C4-0

OVERALL GRADING PLAN

5		
4		
3		
2		
1	08/01/2023	PER TOWN OF ROLESVILLE COMMENT
REV	06/01/2023	INITIAL SUBMITTAL

C5-8

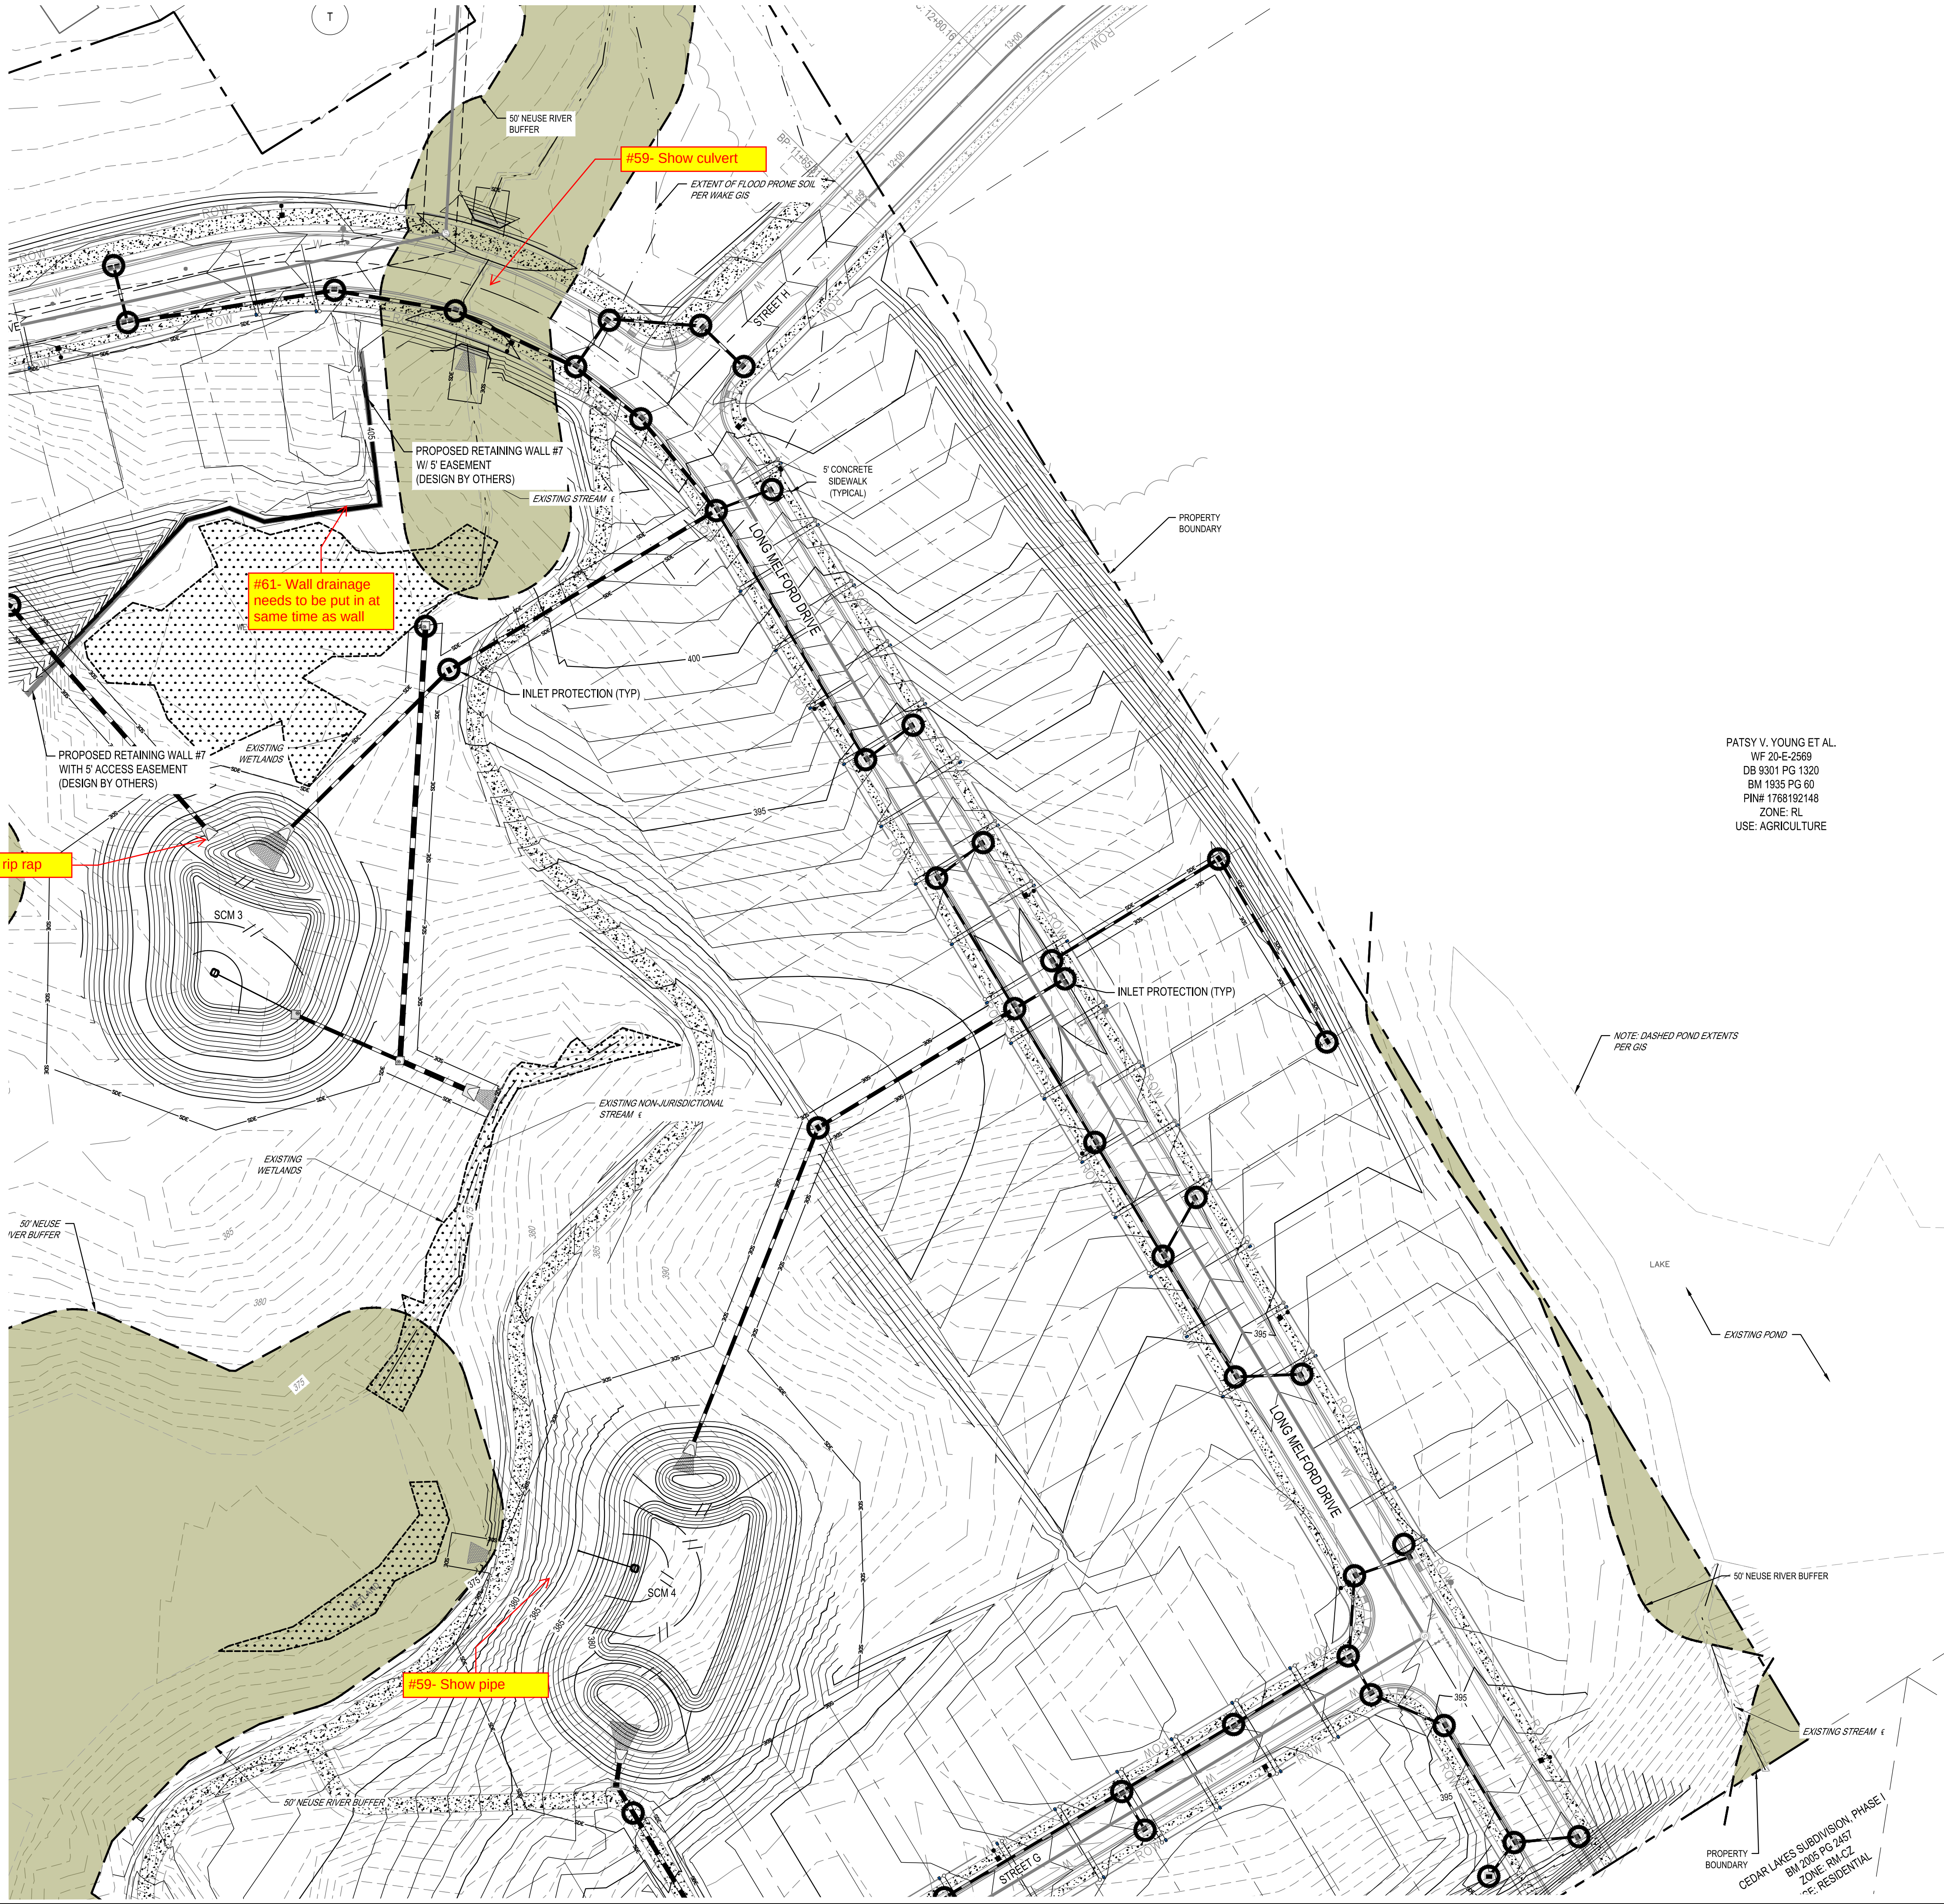
#17- Repeat comment: Please ensure proposed grade ties in to existing

#58- On all erosion control sheets: Please show silt fence for protection until construction is done

#59- Show culvert

#59- Show structure
to be put in as well as
inlet protection
around it

#31- Add proposed
contour labels to
SCM

#59- Outlet pipe not
showing
